Interim Wastewater Pond Management Plan
US Magnesium LLC
Rowley, Utah

Submitted to: U.S. Environmental Protection Agency, Region 8

October 6, 2017

Subject: Approval of the Minor Changes to the Construction Permit and Engineering Drawing

TYPICAL PIPE TRENCH
AND BEDDING DETAIL
N.T.S.

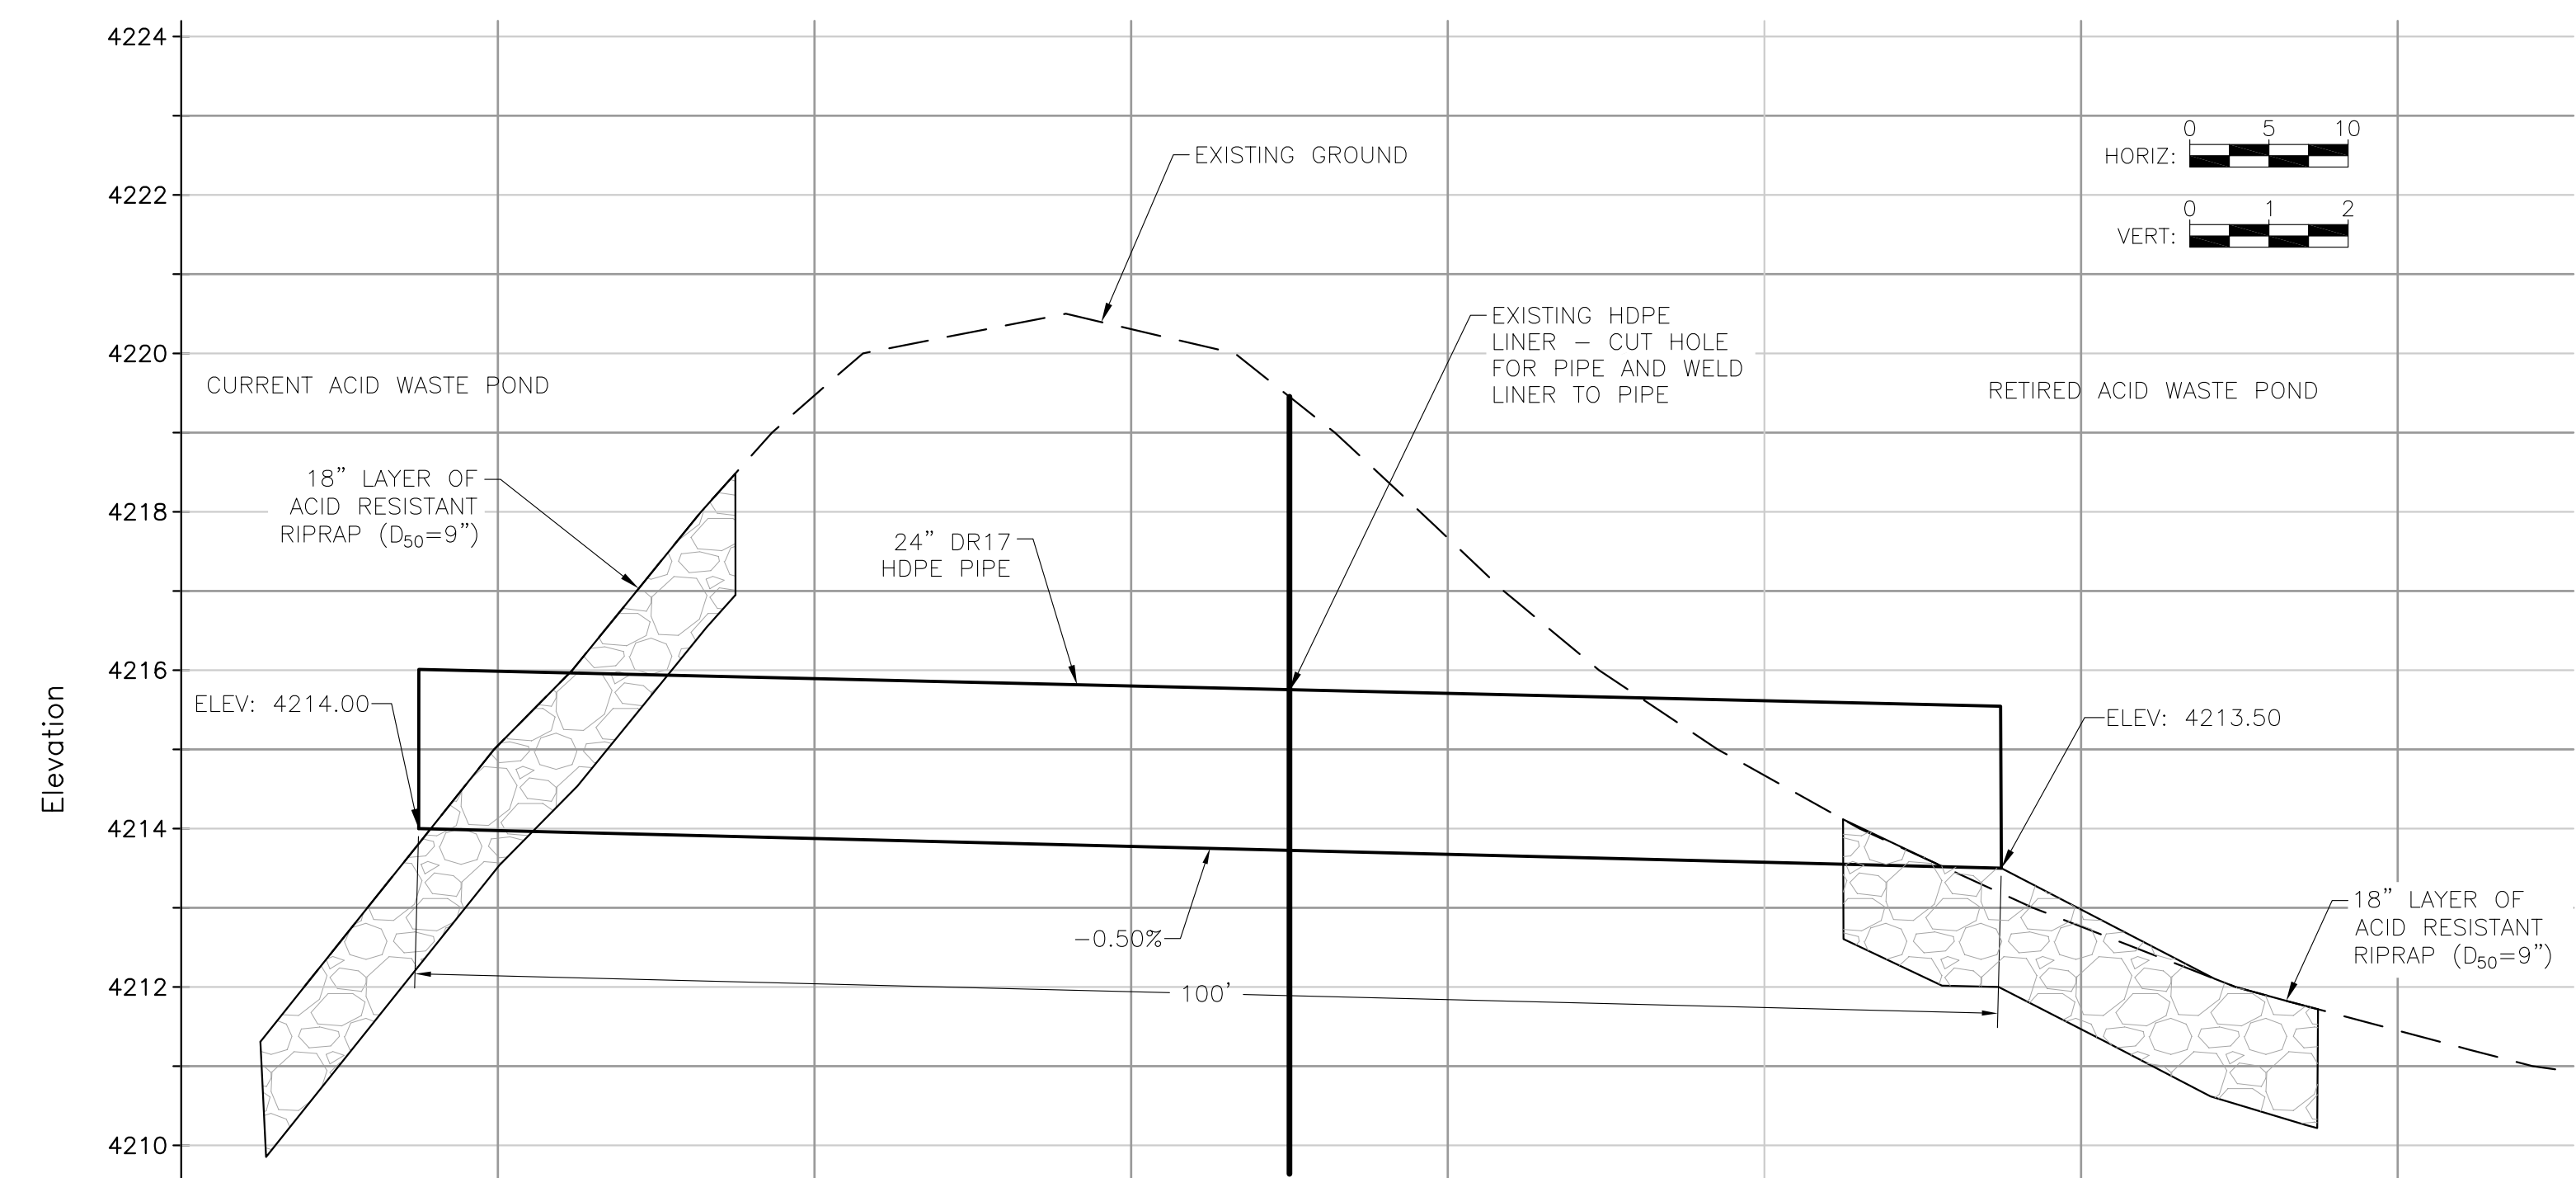
- the roadway will be built up to provide a minimum of 2-feet of roadbase above the pipe;
- the invert pipe elevation is only about 4 to 6 inches above the top of the existing HDPE liner so the pipe will be placed over the top of the liner (the smoothed contours on Drawing SK-170314, Rev. 0 indicated that the pipe would penetrate and thus be sealed/booted to the existing liner); and
- addition of a butterfly valve.

1. The roadway will be built up to provide a minimum of 2-feet of road base above the overflow pipe,
2. The elevation of the HDPE pipe has changed with the inlet elevation being 4214.00 and the outlet elevation being 4213.46, and
3. Installation of a butterfly valve.

These changes are hereby approved.
